Pentavia, Mill Hill

Planning Addendum
May 2019

GLA COMMENTS SUMMARY

Comment 1.1 - Updated Overall Plan (Level 3)

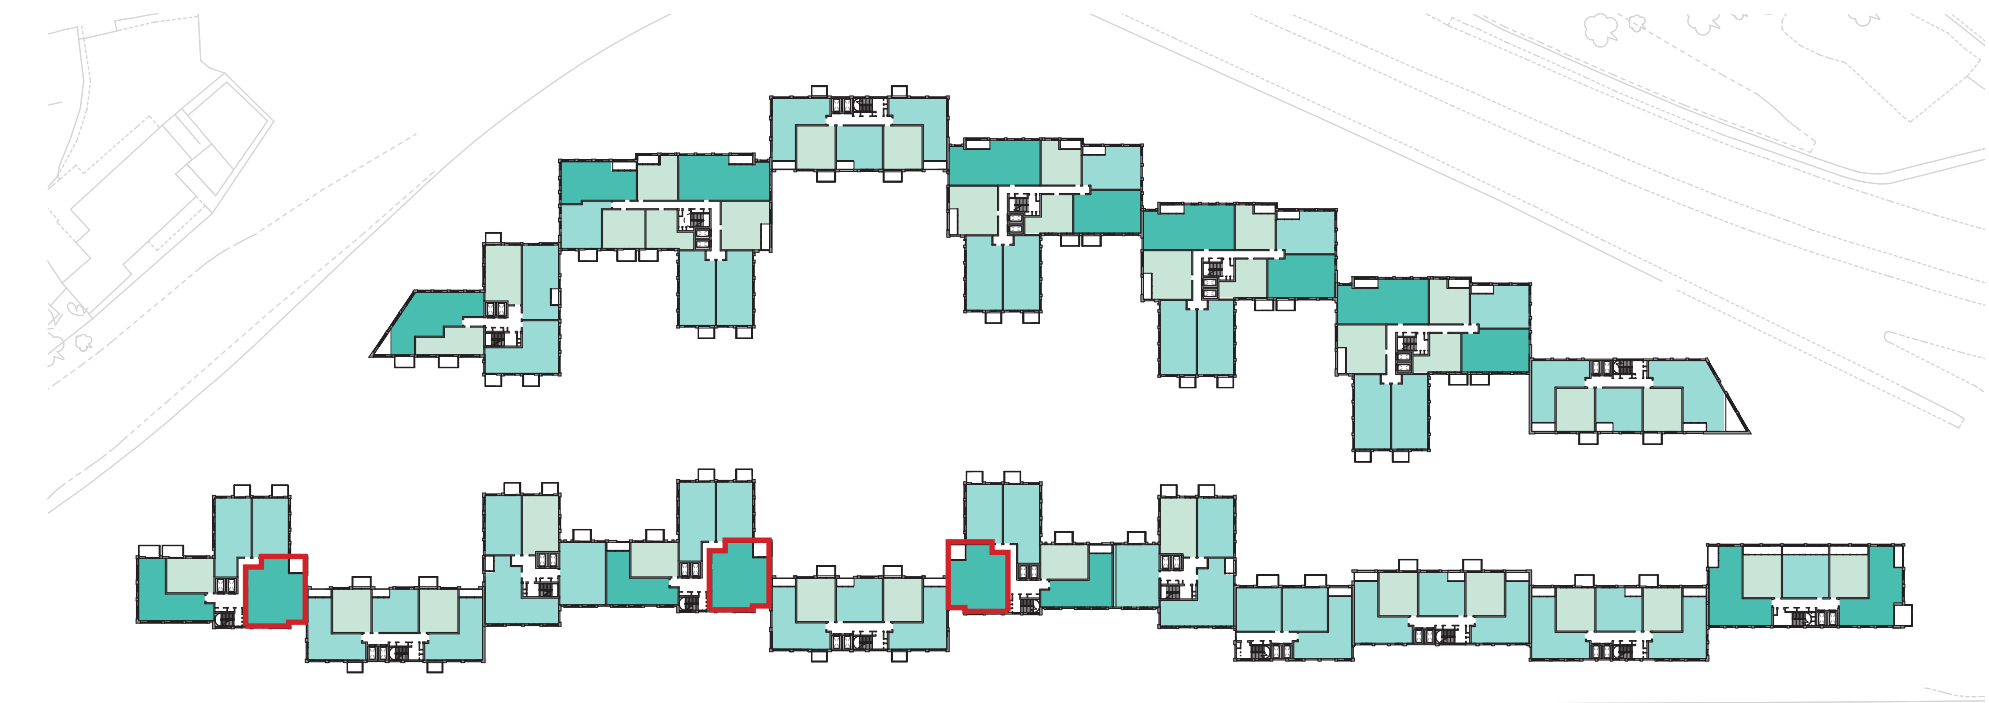
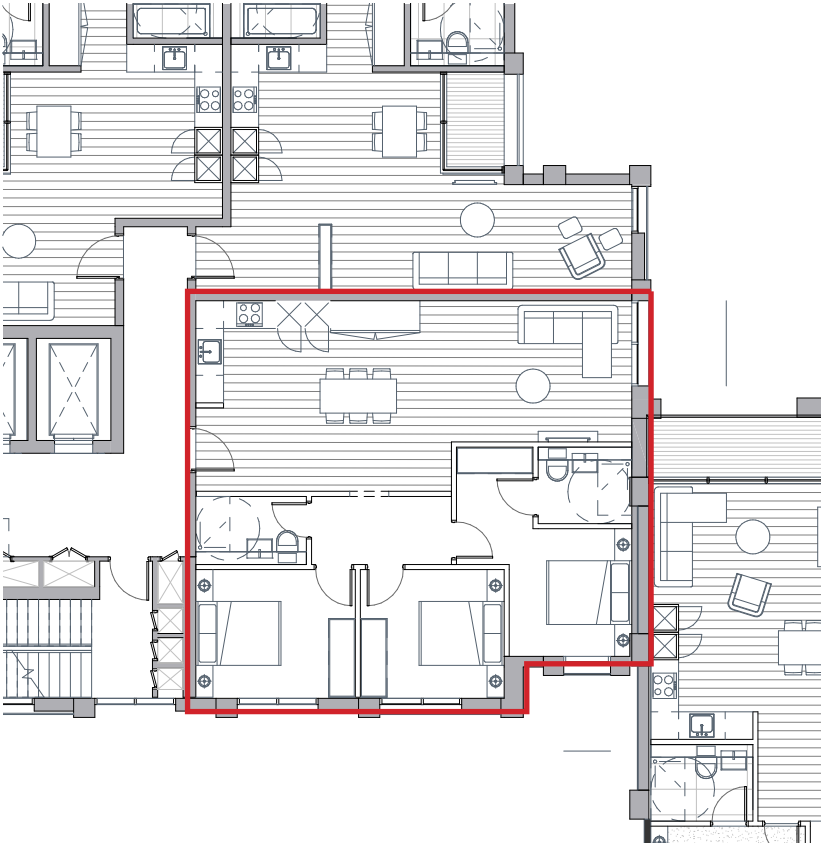
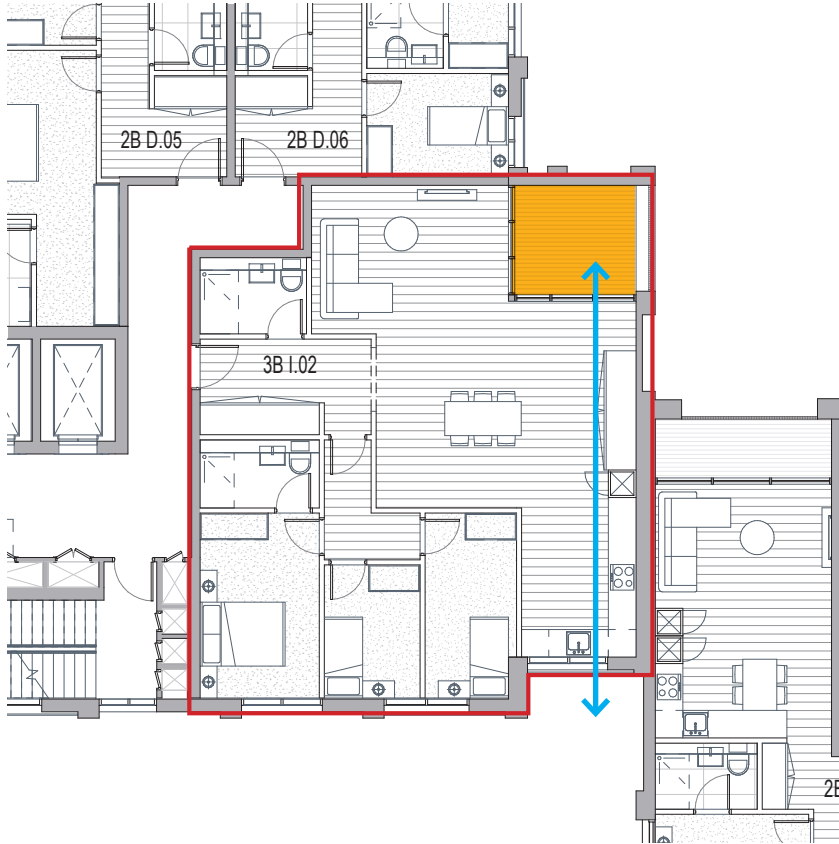
- There are a number of 3 bedroom units located within courtyard corners on blocks adjacent to the M1 where, having reviewed the floorplans in detail, we are of the view that the living space would be of a poor quality due to their narrow nature and outlook which would provide insufficient daylight. These units would also lack any private amenity space and be compromised in terms of privacy issues due to the location of adjacent balconies and communal entrances. This isn't going to be acceptable and the residential quality must be improved. For example, the living space within these units could be rotated 90 degrees so as to benefit from two aspects. This may reduce the size of units in terms of bedrooms and hab rooms. Alternatively, you may wish to consider more fundamental revisions to the internal layout to ensure these units are of an acceptable residential quality.

- Living spaces have been re-orientated to have dual aspect and private amenity provided to allow sufficient daylight.
- Balconies have been moved away from corners to eliminate private / overlooking issues.

- ↔ Dual aspect provision
- Orange box Balcony added, away from the corner

Comment 1.2 - Updated Overall Plan (Level 3)

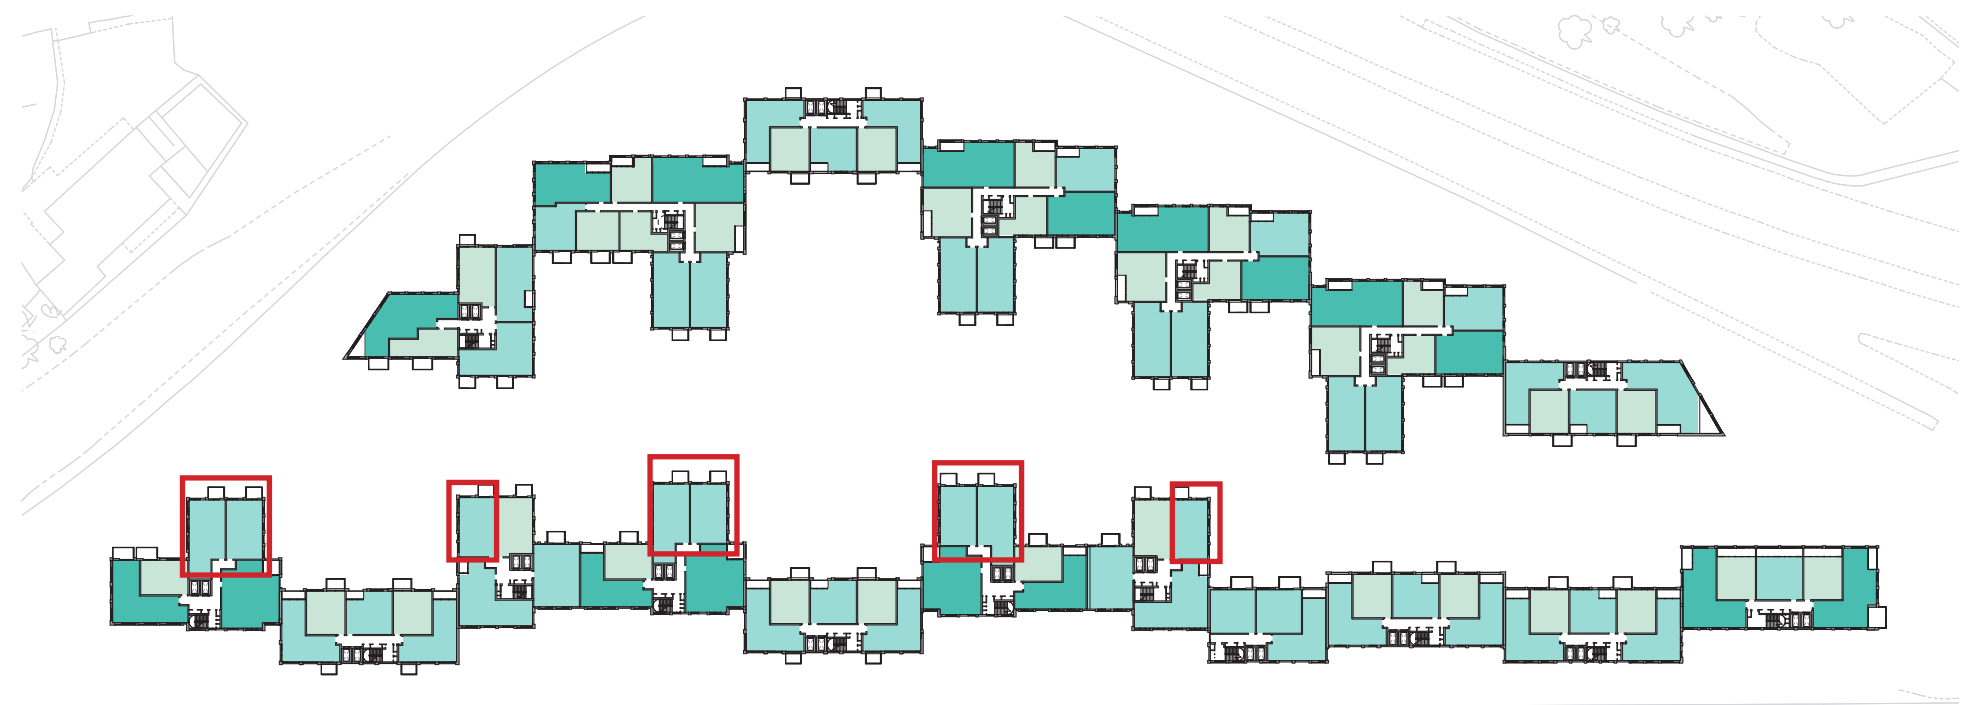
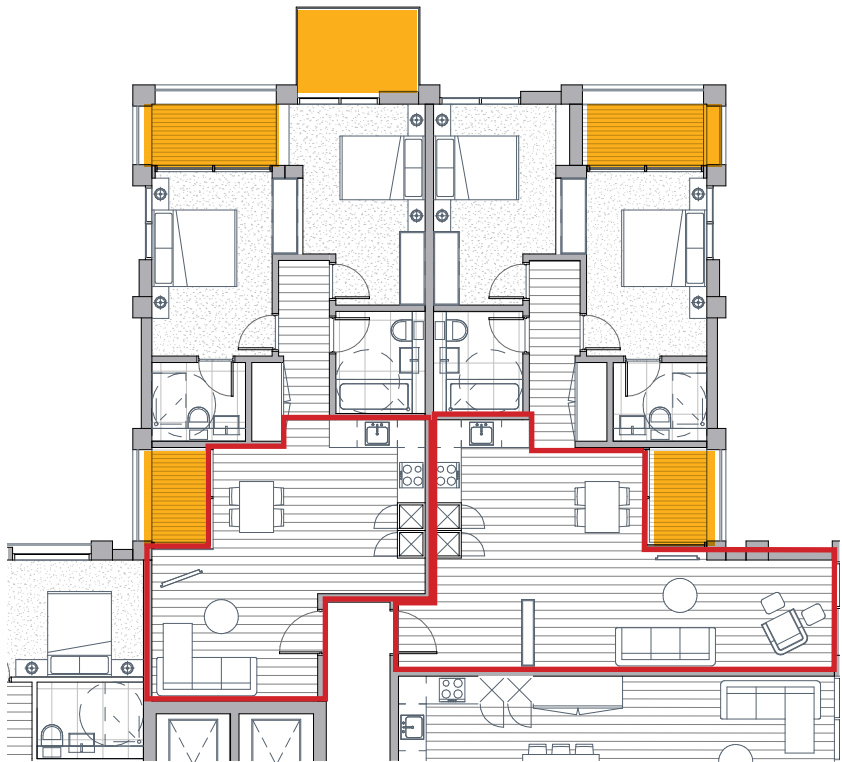
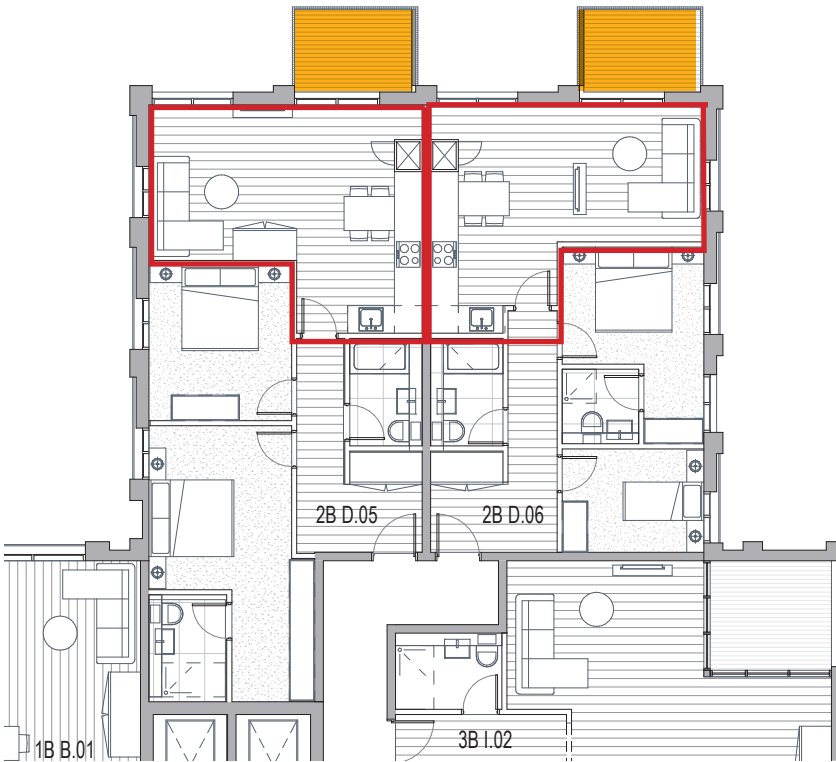
- Units having multiple balconies (which is not necessary), or where the placement of balconies means they serve bedrooms rather than living rooms

- Some units have been flipped so the living spaces face the courtyard increasing the daylight and eliminating the overlooking issues with the adjacent blocks in the corners
- Multiple Balconies have been reduced and placed mainly on living rooms

- Revised balconies configuration
- Revised living spaces location

Comment 1.3 - Updated Overall Plan (Level 03) with revised units

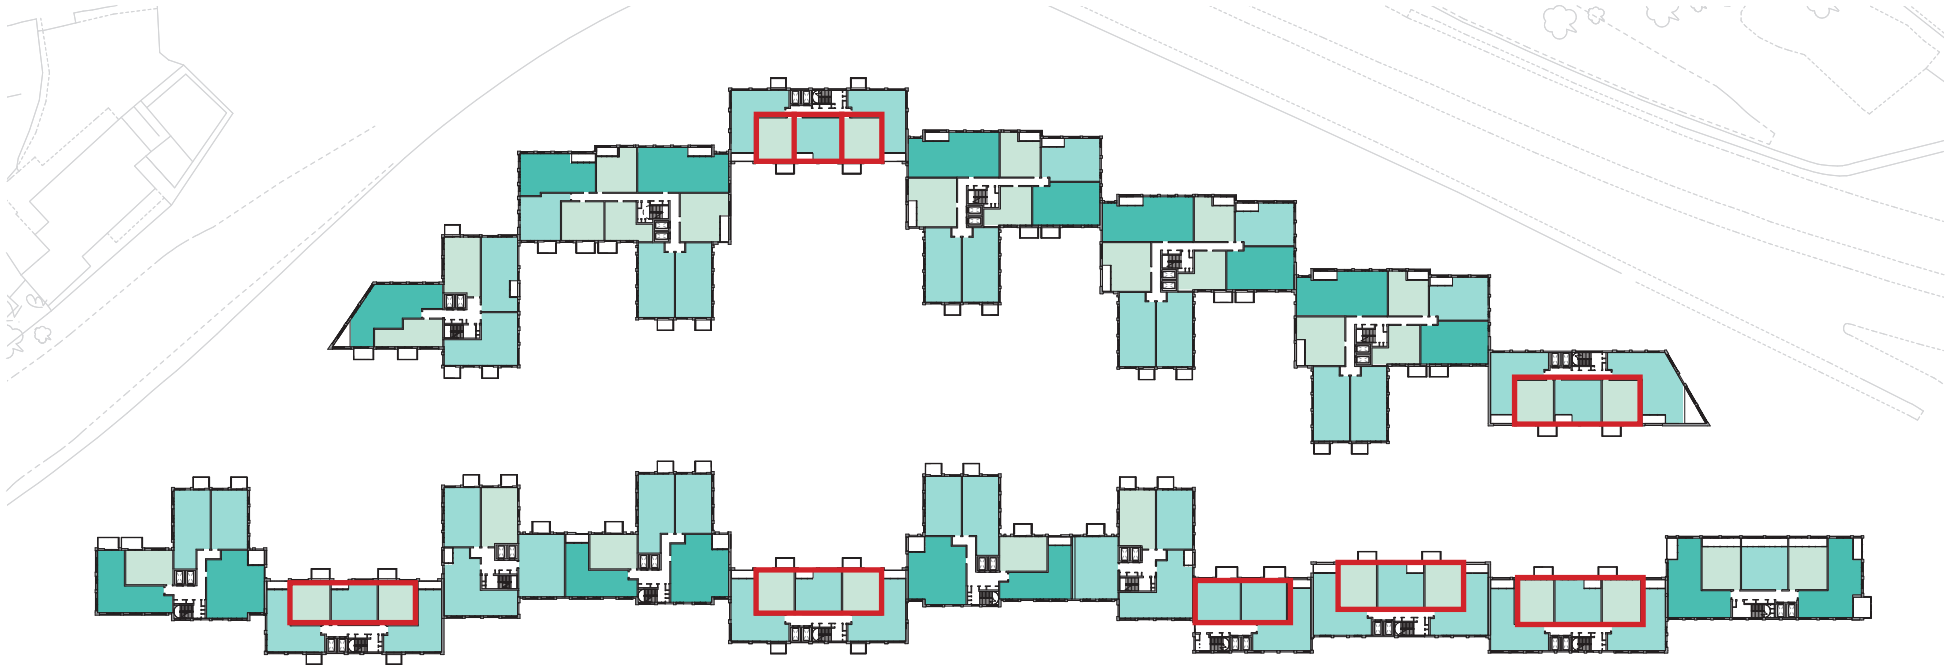
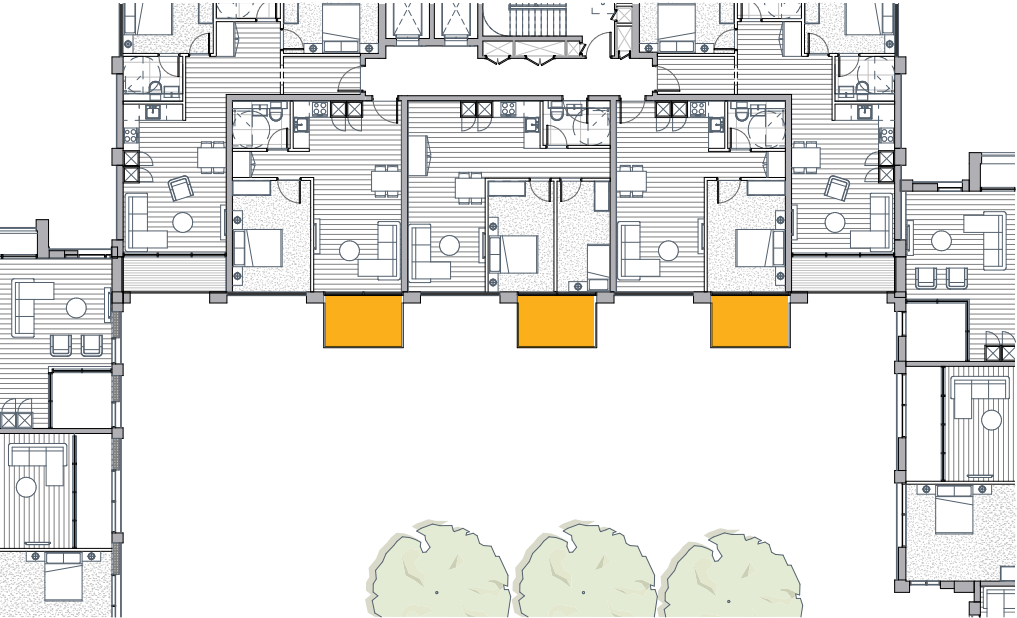
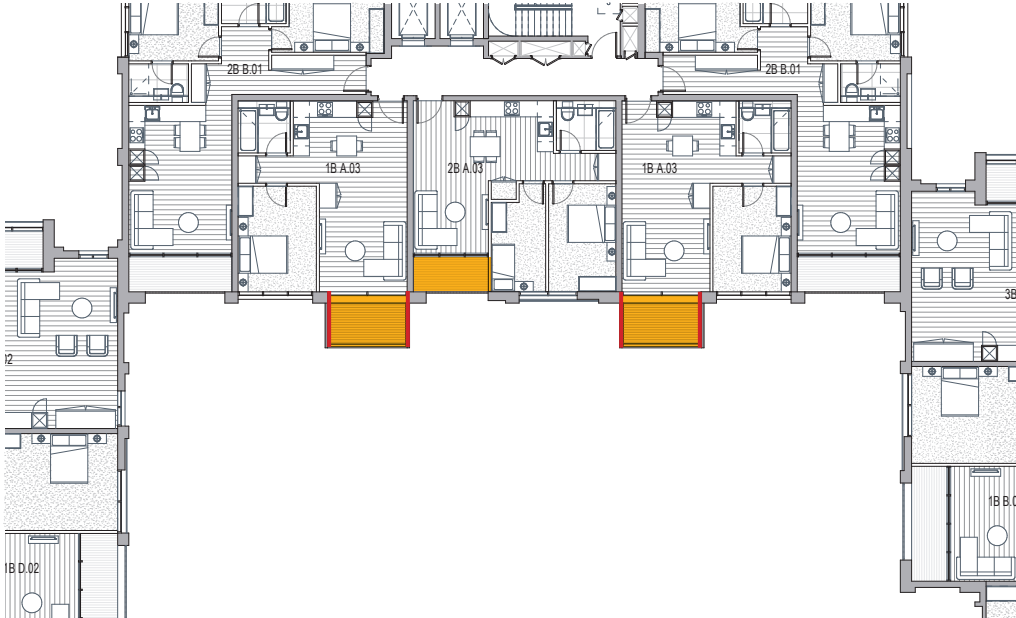
- Upper floors – there are a number of instances highlighted on the annotated plans where the placement of balconies would lead to overlooking issues between units facing each other across the corners of courtyards. This is sometimes caused by some of the units having multiple balconies (which is not necessary), or where the placement of balconies means they serve bedrooms rather than living rooms and are consequently closer to the living room on adjacent facing block. This could be addressed by either removing multiple balconies serving units; or by moving the balcony inwards into the centre of the courtyard as illustrated in the annotated plans. This would also have the benefit of ensuring the balconies would serve living rooms, rather than bedrooms.

- Recessed balconies added in some living spaces to eliminate overlooking between different units
- Balconies / winter gardens serving living spaces
- Solid sides have been added for privacy

- Revised balconies configuration
- 1.8m opaque side provided
